Hood Insulation with Adhesive Backing

M-821-003

(June 2008)

Mack CXU models built before February 2008.

Case description

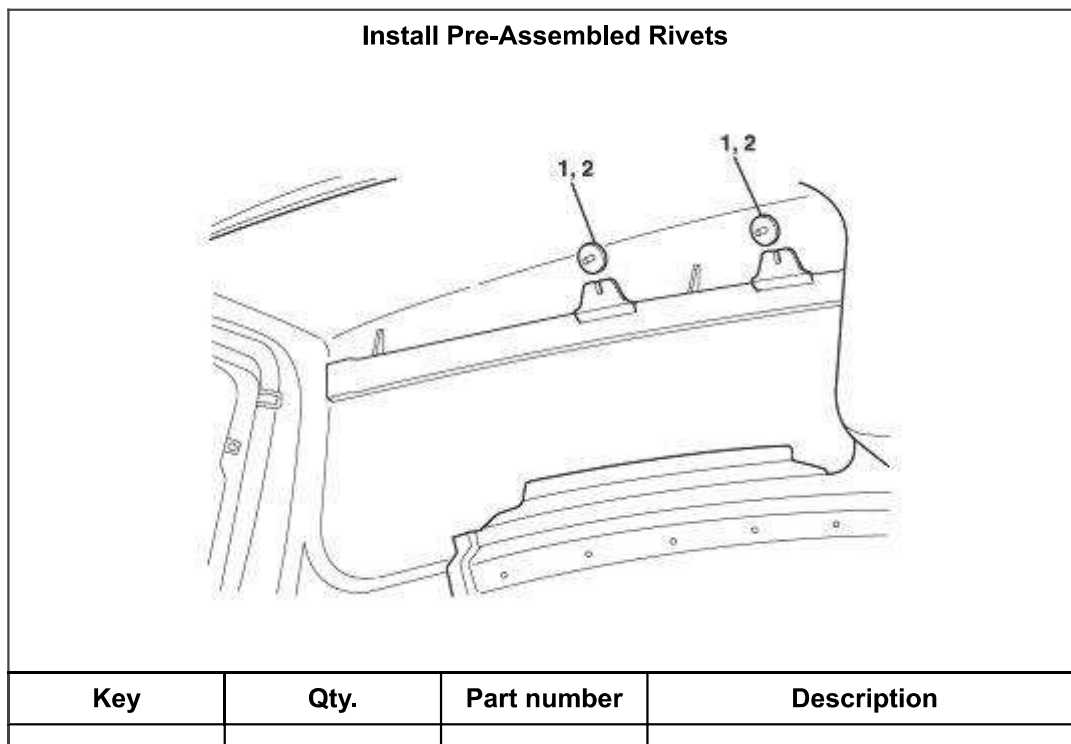
On CXU model chassis, the fasteners used to secure the sound insulation material to the hood may not be sufficient for holding the material in place. Effective February 12, 2008, revised sound insulation material (part Nos. 9RU4223M [82197159] and 9RU4224M [82197161]) having an adhesive applied to the back of the material was implemented into production. Should complaints of the sound insulation material coming loose and falling off the hood be encountered, replacement of the existing material with these revised insulation pieces is recommended.

<p>Remove Backing Material from Adhesive Strips</p>  T8186403
<p>1. Split Line in Backing Material</p>

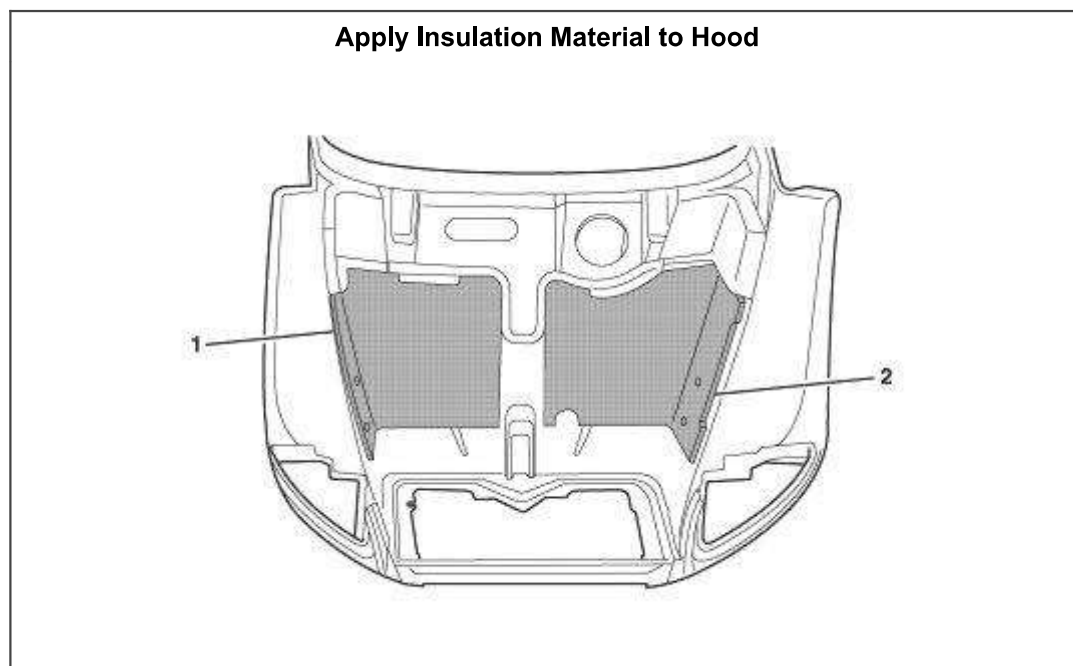
5. Remove the backing material from the back of the insulation material (part Nos. 9RU4224M [82197161], right-hand side, and 9RU4223M [82197159], left-hand side).

6. Position the insulation material on the underside of the hood, and then apply sufficient force (approximately 7 kg [15 lbs]), preferably with a roller, to ensure good surface contact between the adhesive and the hood.

Note: The insulation must be applied to the hood within 10 minutes after the backing has been removed from the adhesive.

<p>Install Washers</p>

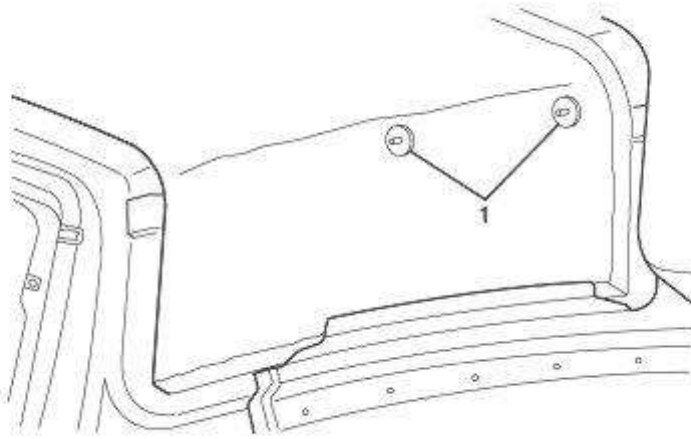
7. Install the washers (part number 25155206) onto the rivets.
